Agenda item title: * 6.1 Planning Permit Application: TP-2022-195 186-190 Lygon Street, Carlton

Agenda item title: * Agenda item 6.2 Planning Permit Application: TP-2022-229 6-10 MacArthur Place North, Carlton

Attn Future Melbourne Committee

P8 Views showing the effect of adjoining sites with excessive site coverage up to 10 m height like the proposal.

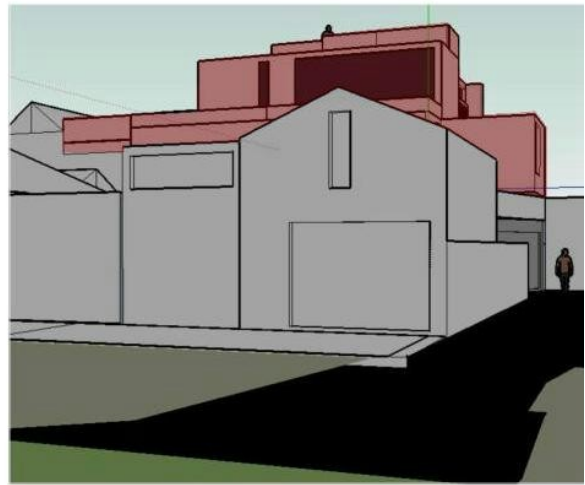
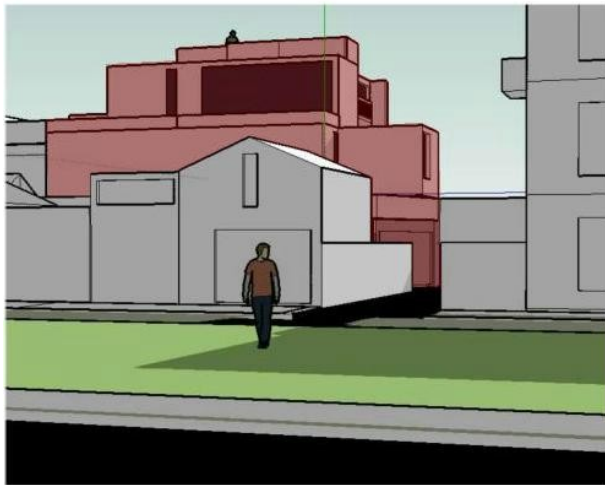
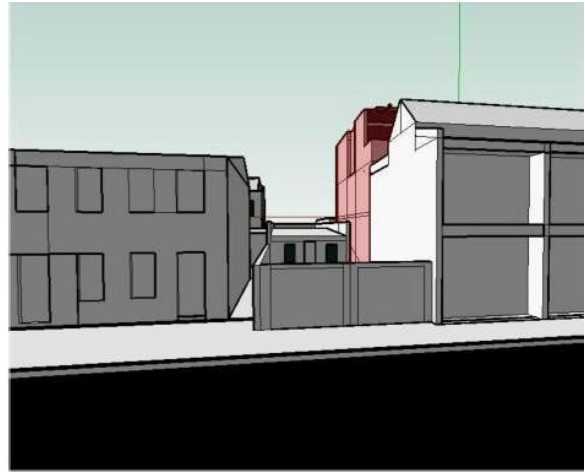
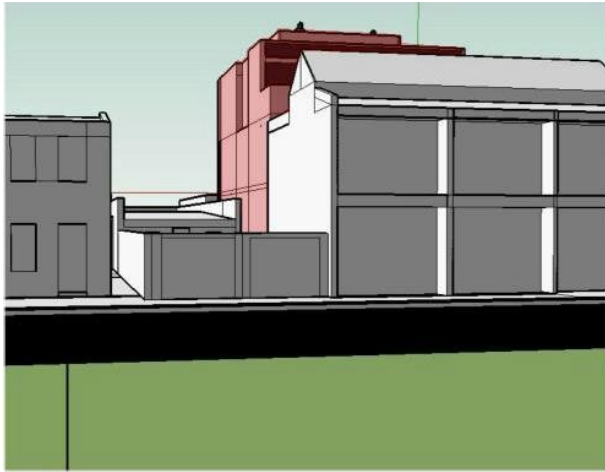
4. I draw your attention to and request that you consider the images I have generated of adjoining sites with the same site coverage as the proposal. Please refer to P8 below.

P9 Views of the proposal from exactly the same viewpoints but with different viewing angles.

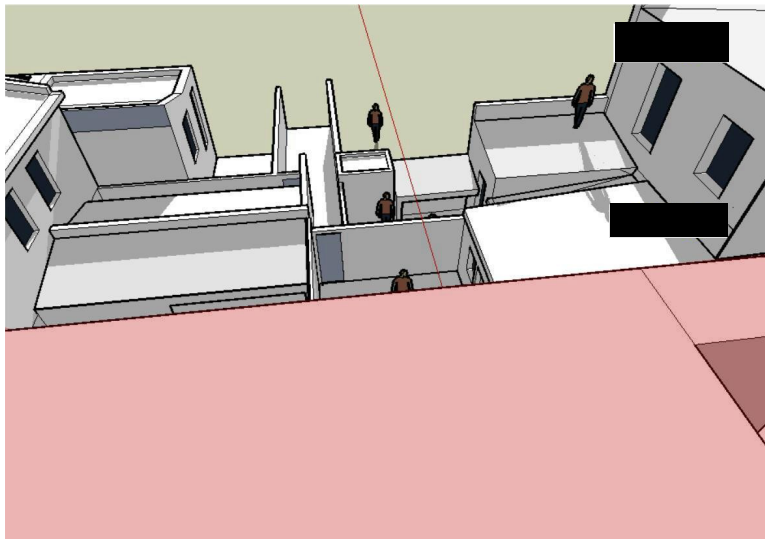
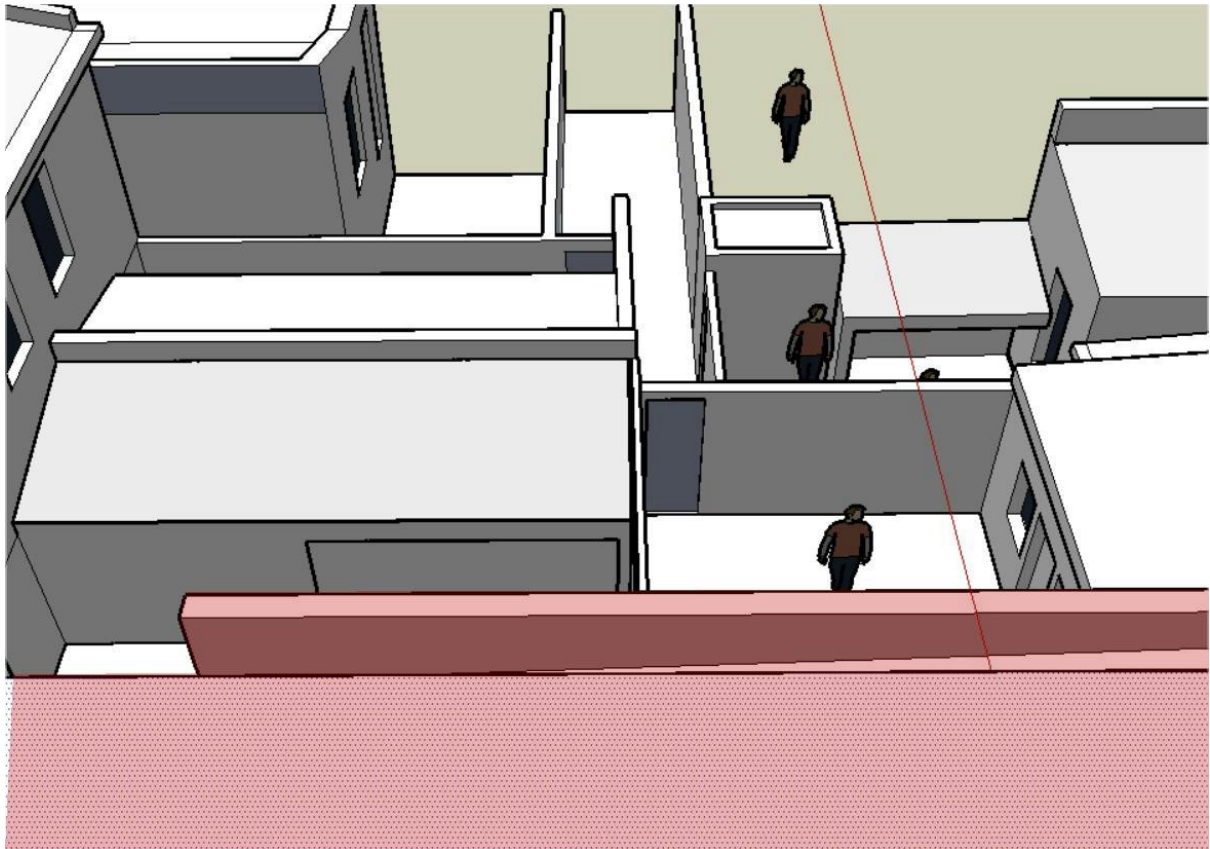
8. I have included duplicate views from the same viewpoint but with different “viewing angles” to demonstrate how a “wider” viewing angle than normal human vision tends to emphasise the height of foreground objects in comparison to distant objects thus reducing the apparent scale of distant objects ie: the proposal. Please refer to P9 below.

13. Images on left show the proposal with a viewing angle more consistent with human vision ie: how the proposal would most likely appear (as explained in paragraph 10 above).

14. Images on right were generated with excessively wide angle having the effect of reducing visual bulk of the proposal similar to the applicants images.

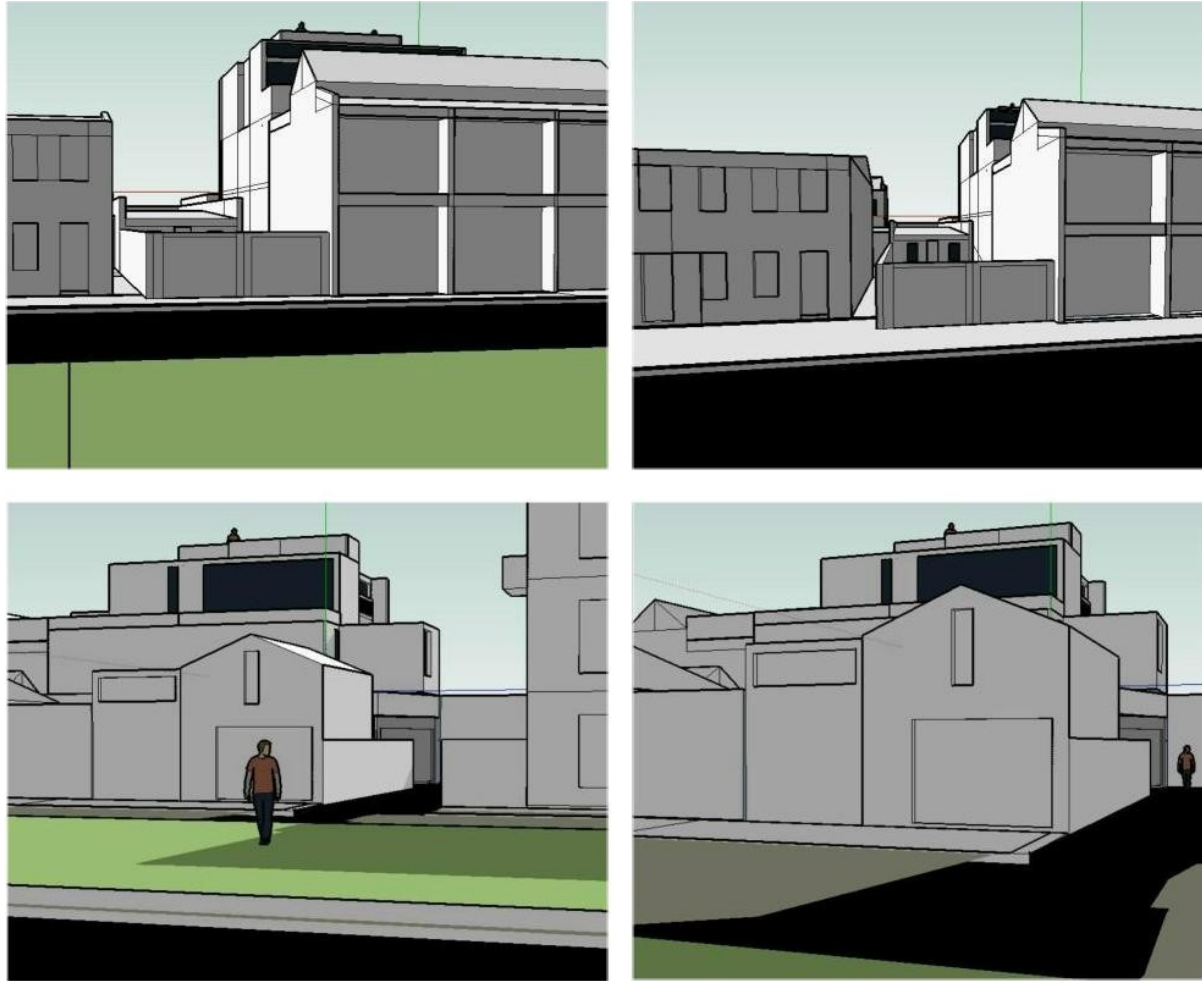
The applicant's 3d photo montage from this locations might have been generated with a wide angle which would have the effect of de-emphasising the scale of the proposal.

The following views are from the same camera position but with different fields of view to demonstrate this effect. The images to the right have been generated with an excessively "wide angle".

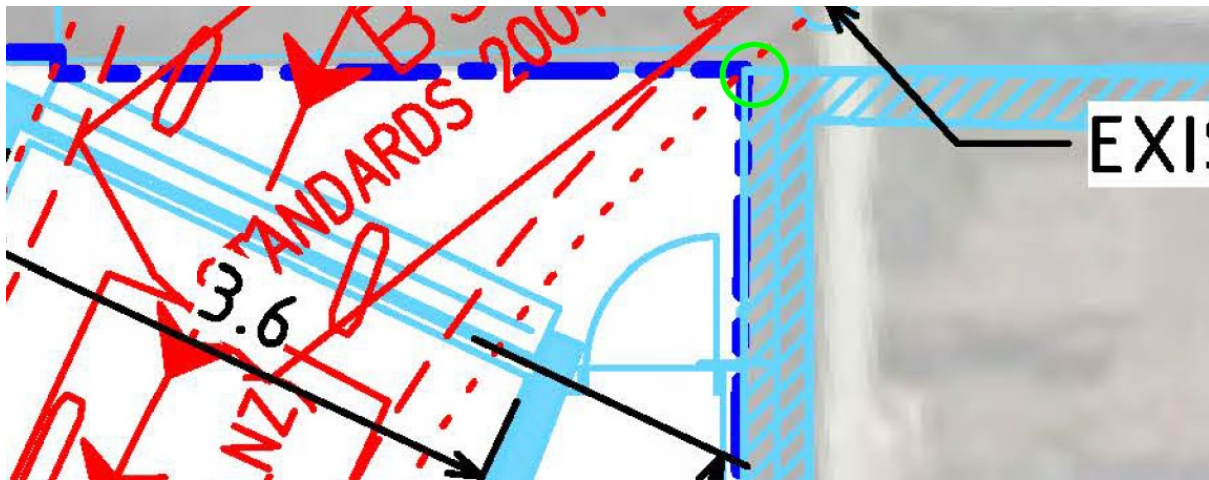
Not meeting the Standard minimum also means that drivers will need to perform corrective manoeuvres to avoid the north western wall and the walls relevant to entering the lift. Unpredictable driver manoeuvres will only add to the safety issues in the laneway.

The unacceptable B99 180mm / 120mm exit encroachment occurring over the property of no.4 Macarthur PI Nth is not mentioned in the response (the property is not an

'object'), even though it is documented in the developer's swept paths. You would expect that it would be unusual for a car access plan, that basically relies on encroachment into an objecting neighbor's property, to be approved.

New B85 laneway swept paths

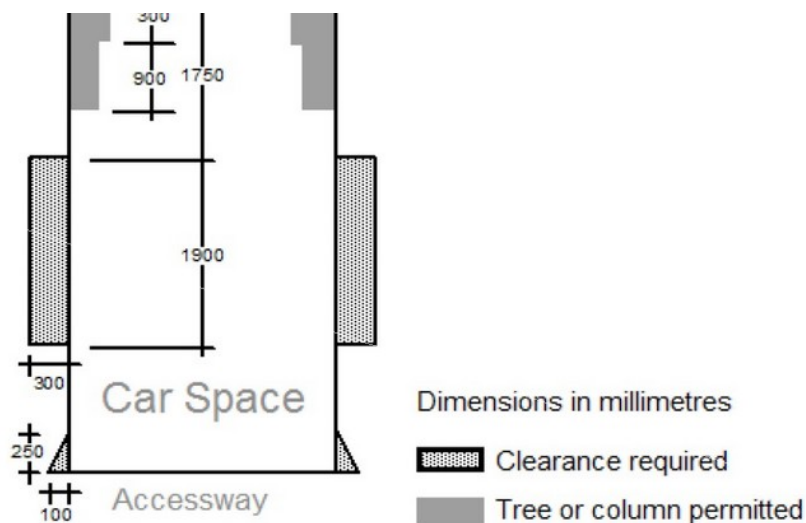
The same properties listed above are impacted in both Entrance and Exit diagrams.

See *DF_IC Pt 2 of 2 Swept Paths Annotated* for indications of where the issues are still occurring.
